A G E N D A JAMES CITY COUNTY DEVELOPMENT REVIEW COMMITTEE REGULAR MEETING

Building A Large Conference Room 101 Mounts Bay Road, Williamsburg, VA 23185 July 27, 2016 4:00 PM

SUBJECT: The Promenade at John Tyler: Appeal of a decision of the Director of Planning

SITE PLAN-0052-2016. Williamsburg Memorial Park Ossuary

UNDISTURBED NATURAL OPEN SPACE

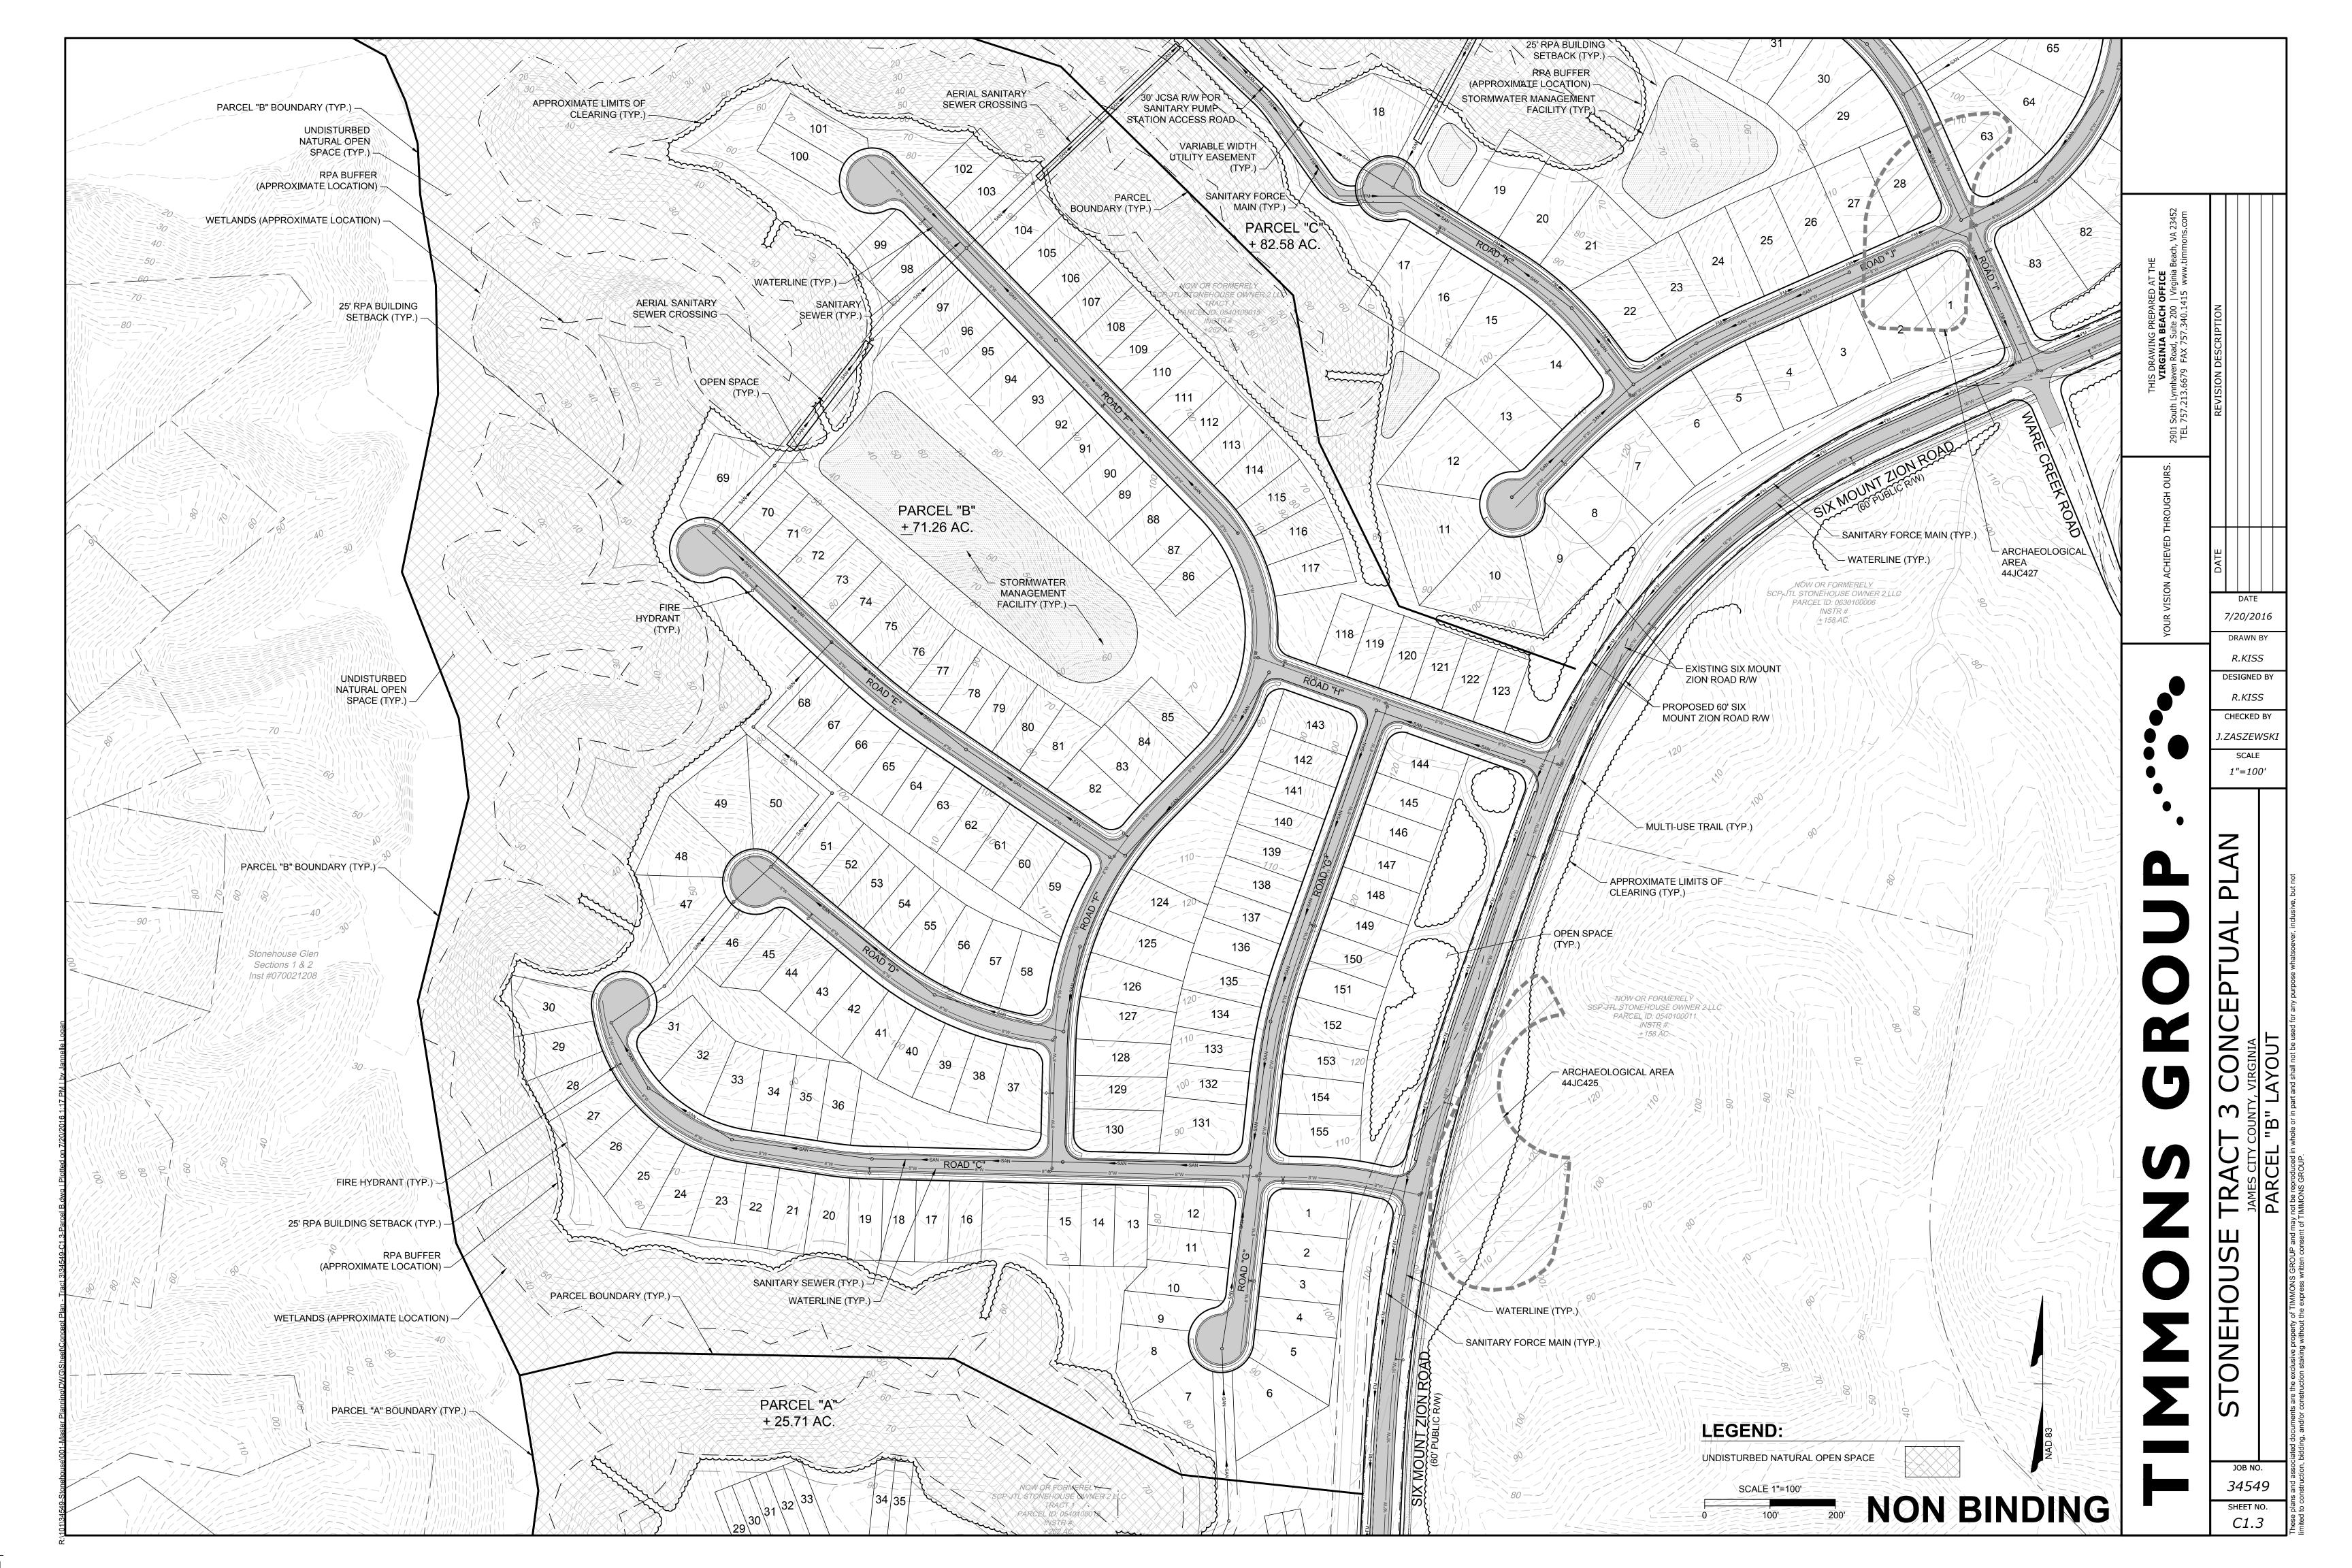
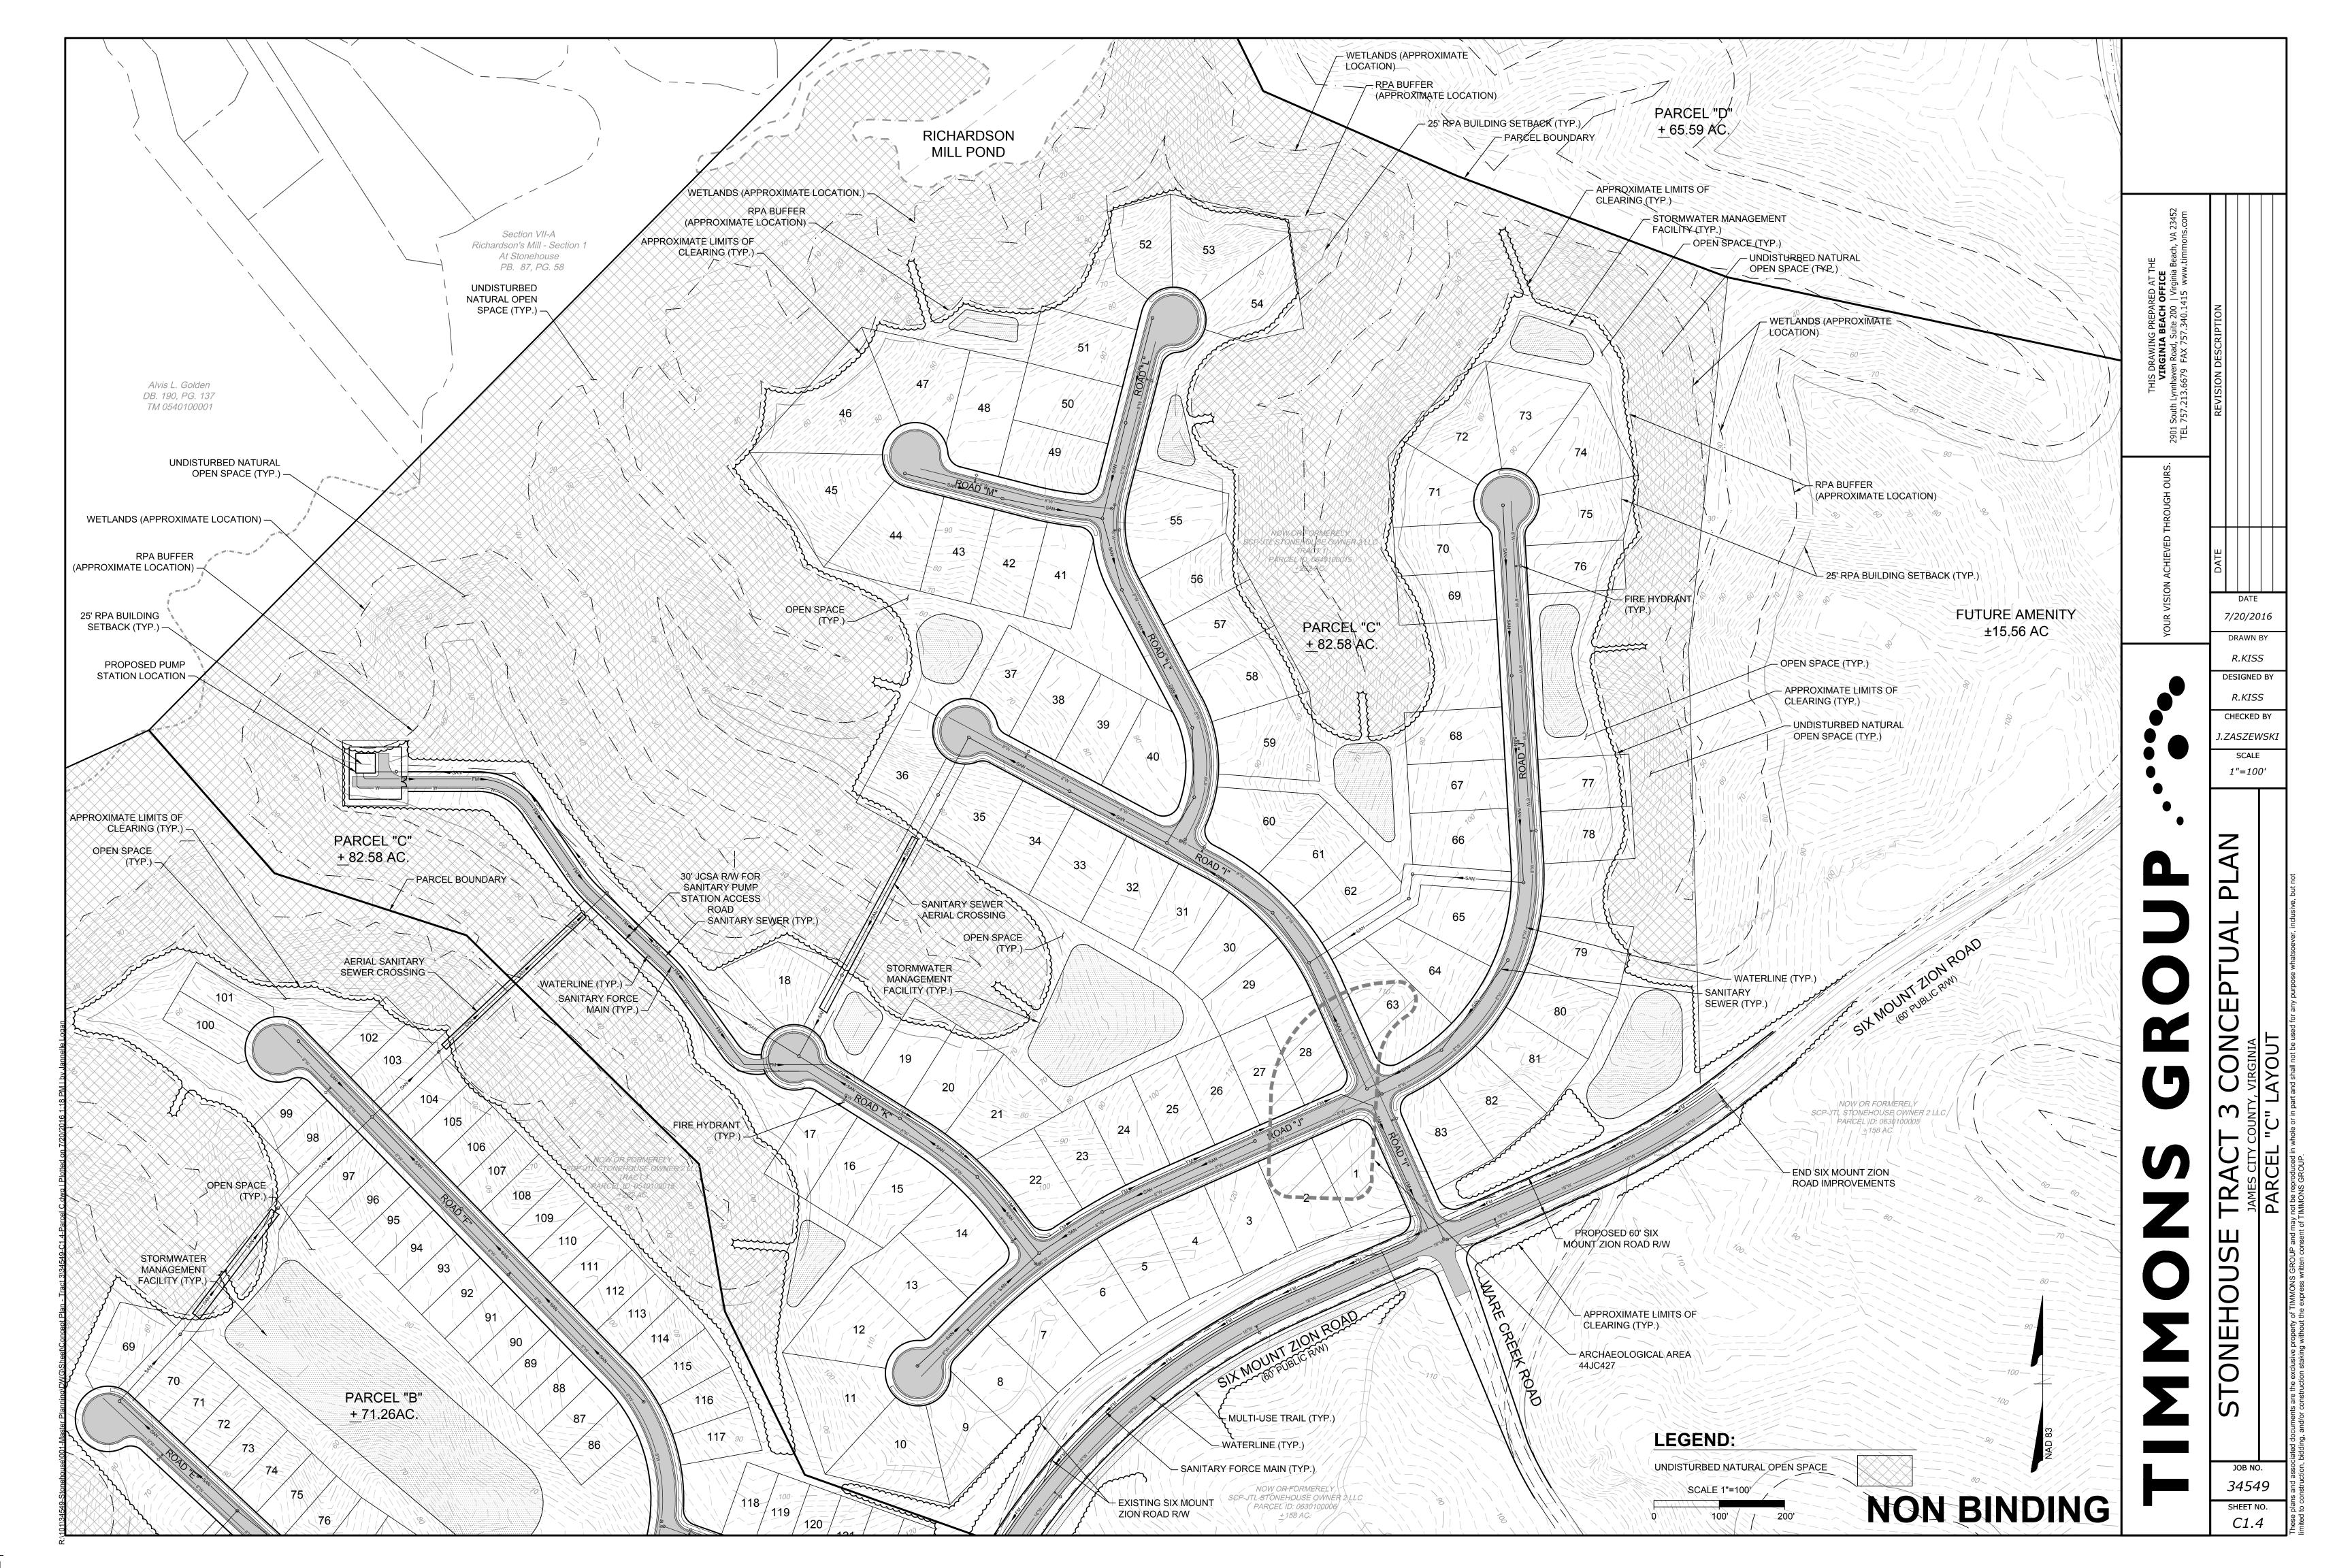
- be references to approved rezoning case Z-06-12 and Z-04-07 which have additional proffers applicable to this land bay.
- 4. Labels. On the conceptual plan cover sheet, provide a label to indicate Richardson Mill Pond with County BMP ID Code WC059. On conceptual plan drawing Sheets C1.1 and C1.2, label the Laurel Park Grove Clubhouse (ie. Amenity Center H) with text to identify approved County Plan No. SP-08-09. On Sheets C1.1 through C1.4 include text to indicate VDOT State Route number, as applicable, for Six Mount Zion/Holly Forks Road (ie. SR600, etc.).

- 19. BMPs. On detailed conceptual development plan Sheets C1.2 through C1.4 label the type of stormwater management/BMP facilities as proposed consistent with County BMP manual designations (ie. wet extended detention, dry detention, timber walls, dry swale, bioretention, etc.).
